RE: **Recall Campaign Launch Notification**  
**Relocate Grounding for the Illuminated Star**  
**MY20 167 (GLE-Class, GLS-Class)**

Campaign No. 2020100015, November 2020  
Revision A

SUBJECT: **Model GLE-Class and GLS-Class vehicles (167 platform)**  
**Model Year 2020**  
**Installation of the Illuminate Star**

Figure 1

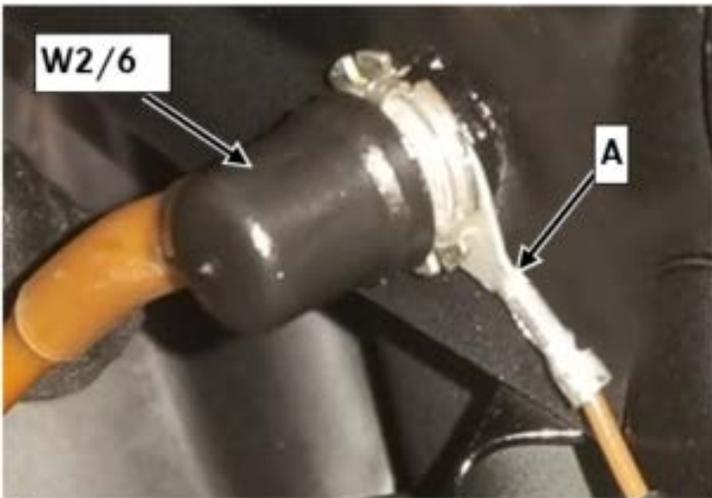
1. Open hood.
2. Switch off ignition and store transmitter key outside the transmitter range (at least 2 meters).
3. Unscrew ground **point W2/6**.  
i For basic data, see **GF00.19-P-2001-17NCA**.
4. Remove illuminated star ground line (**A, figure 1**).

- Check ground line clearance.
- Ground line may be zip tied to shorten original length.
- Check behind the illuminated star for any possible zip ties around the ground wire.
- Zip ties may be removed for extra length if needed.

6. Route illuminated star ground line (**A, figure 1**) to jump-start connection point and attach to threaded pin of jump-start connection point.
7. Screw on brass sleeve (**B, figure 2**).  
Nm Brass sleeve 16 Nm.
8. Secure illuminated star ground line (**A, figure 1**) up to jump-start connection point.  
i Ensure a chafe-free routing and attachment of the illuminated star ground line See **AZ88.40-P-0011-01ME**
9. Check anti-twist protection (**C, figure 3**) of cable lug of ground **point W2/6** for damage.

Figure 4

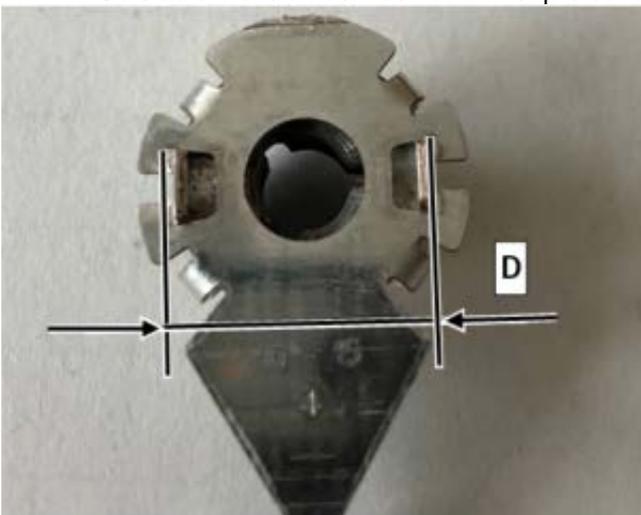
10. Measure outside dimension between anti-twist protection lugs (**D, figure 4**).

i Outside dimension between anti-twist protection lugs (**D, figure 4**) min. 13.6 mm.

- a. Anti-twist protection (**C, figure 3**) **straight** or **bent outwards**, i.e. outside dimension between anti-twist protection lugs (**D, figure 4**) **equal to or greater than 13.6 mm**: Perform operation step 11, then **end measure**.
- b. Anti-twist protection (**C, figure 3**) **bent inwards**, i.e. outside dimension between anti-twist protection lugs (**D, figure 4**) **less than 13.6 mm**: Create **PTSS case**.

**i** Only if anti-twist protection of cable lug is **bent inwards**, i.e. outside dimension between anti-twist protection lugs (**D, figure 4**) is **less than 13.6 mm**.
